RAGING RIVER MINING COMPANY
P.O. BOX 691
REDMOND, WASHINGTON 98052
RAGING RIVER QUARRY
EROSION/SEDIMENT CONTROL PLAN

DODDS ENGINEERS, INC.

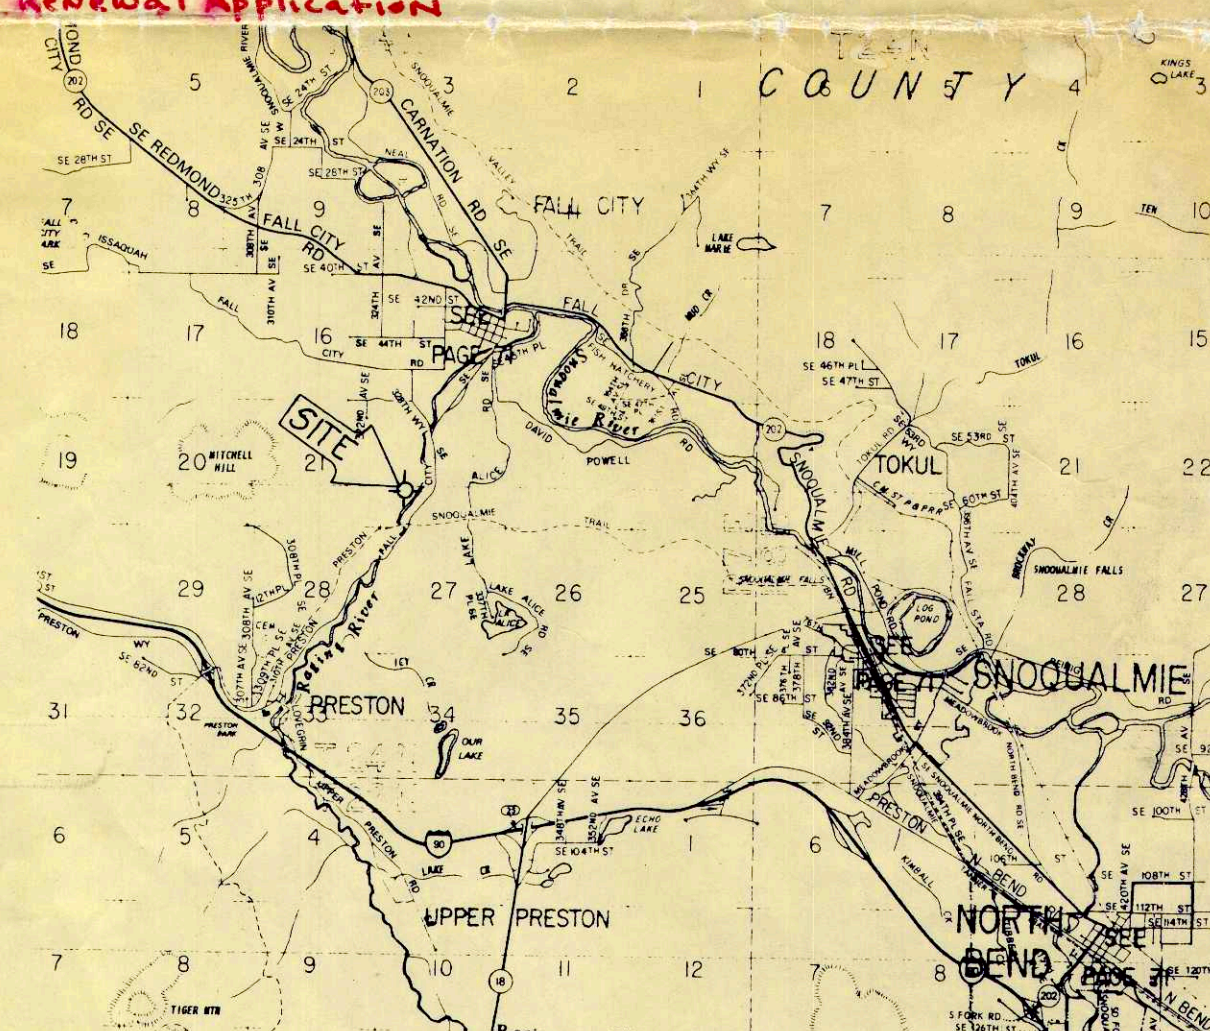
* ANY Future permits for this site or renewals of this permit application MUST provide a DETAILED (MIN. 5' contour INTERVAL) Topographic survey. THIS SURVEY SHOULD show all "as-built" slopes within the existing mining areas, and ANY LOCATIONS for WHICH ADDITIONAL WORK MAY BE PROPOSED UNDER THE PERMIT/ Renewal Application
